# International Residential Code

## 2012 to 2018 Significant Changes

## 12.) R507.4 Deck Posts and R507.4.1 Deck post to deck footing connection

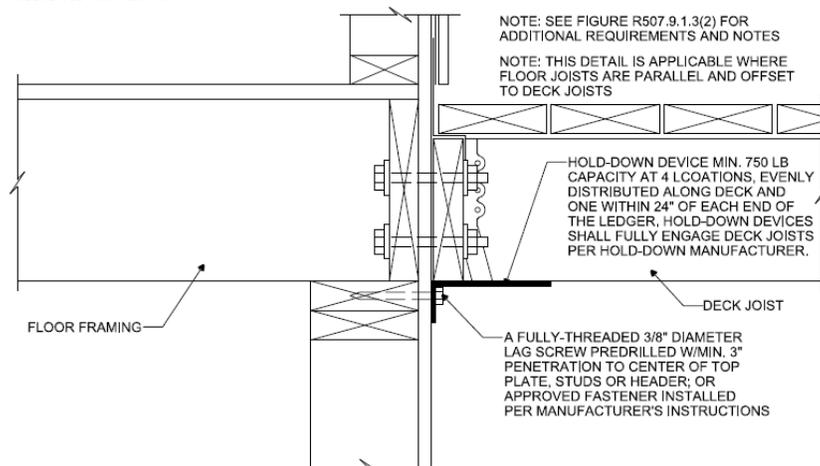
Minimum sizes of wood posts supporting decks have been established as well as requirements for connections of the deck posts to the footings.
